STATE OF LOUISIANA
Department of Public Safety and Corrections
Office of State Fire Marshal Code Enforcement and Building Safety
8181 Independence Boulevard
Baton Rouge, Louisiana 70806
225-925-4920

RE: P0315222
COAST CONCRETE SERVICES
29072 KRENTAL RD
LACOMBE, LA 70445-0000

NFPA 101, 2003

BUSINESS
STORAGE

NEW BATHROOM PLAN

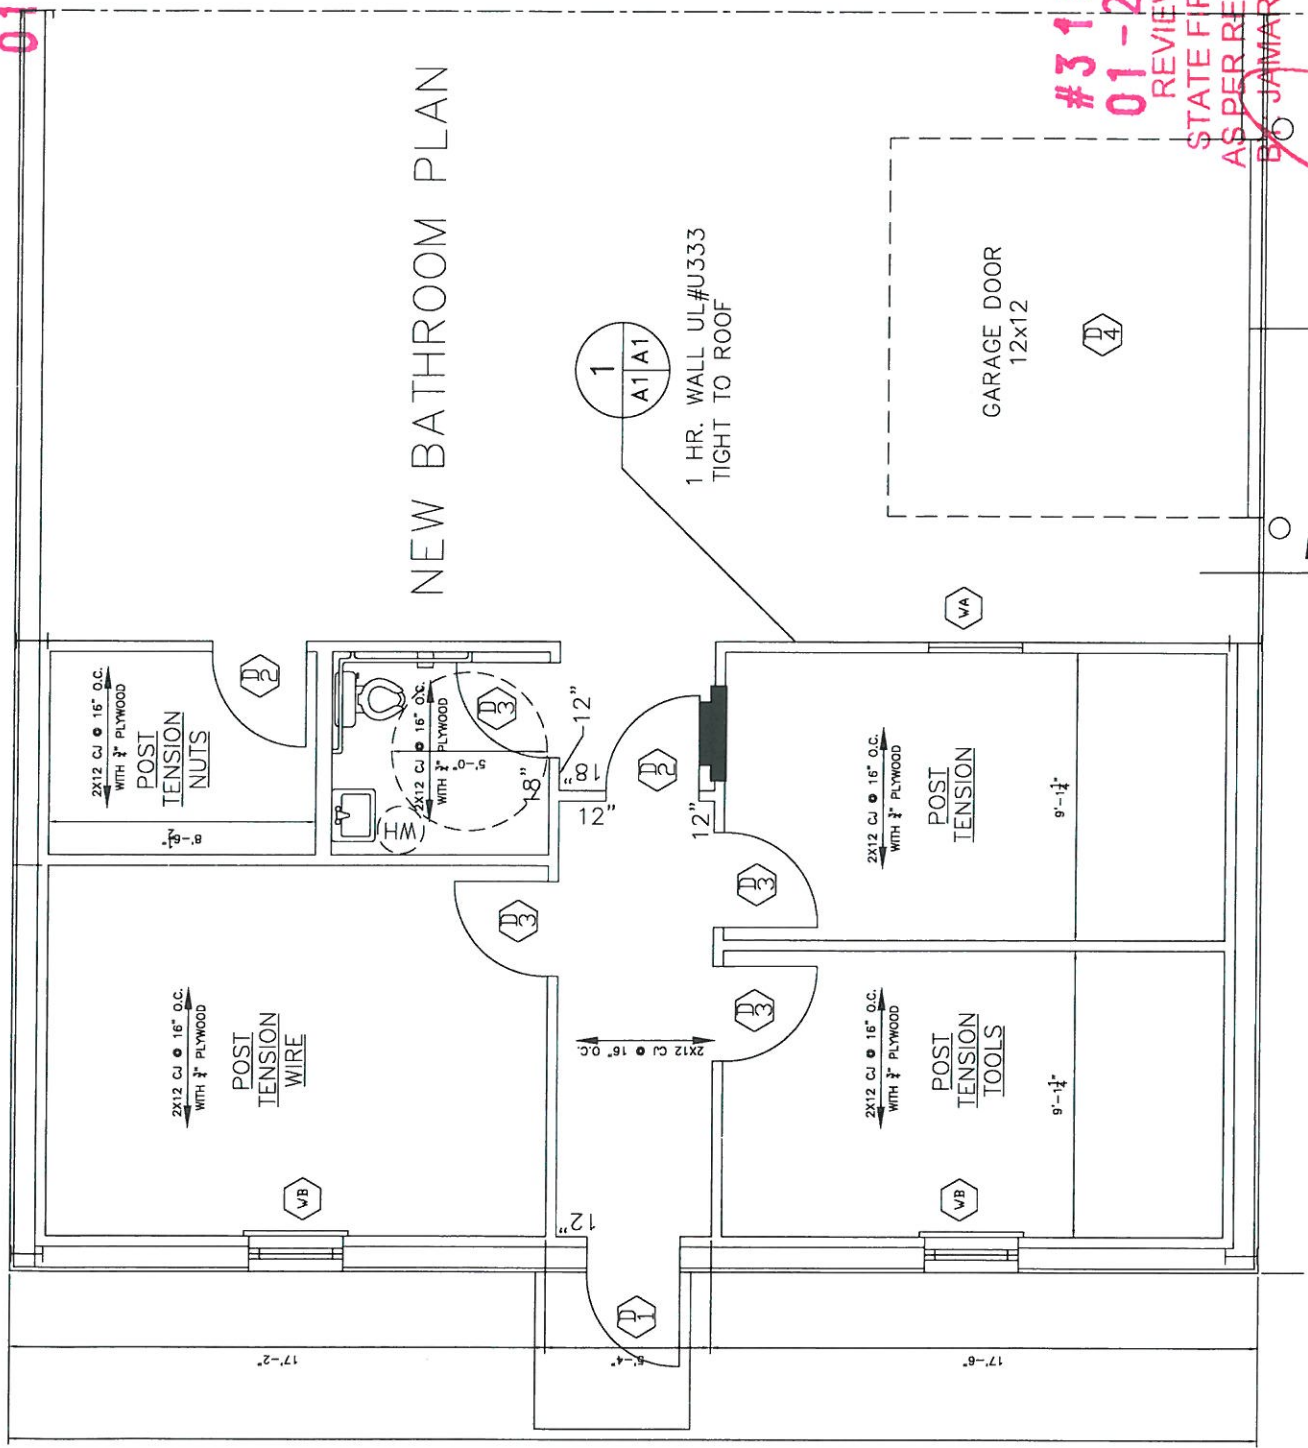
REVISED BATHROOM

LAYOUT!
